DESIGN	DRAWN BY	DART AEROSPACE LTD VICTORIA INTERNATIONAL AIRPORT, CANADA	
CHECKED	APPROVED	DEO 9077	REV. A
97.0	8.21	TITLE 206 SKIDTUBE HOL	SCALE E SPACING CHANGES

DART ENGINEERING ORDER

TO AMEND DWG: DZ650 REV. B

D2654 REV. B

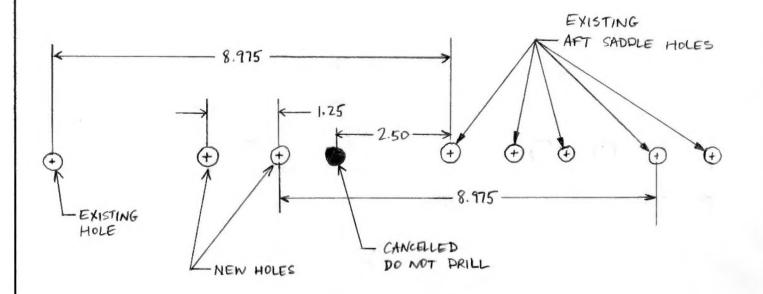
THE HOLE PATTERN NEAR THE APT SAPPLE HOLES OF THE 206B TUBES (D2650-1 AND D2650-3) AND WEBS (D2654-1 AND D2654-3) SHOULD BE MODIFIED AS FOLLOWS:

D2650-1 WILL NOW REQUIRE 19 D2649 CROSS BOLT SPACERS D2650-3 WILL NOW REQUIRE 20 D2649 CROSS BOLT SPACERS
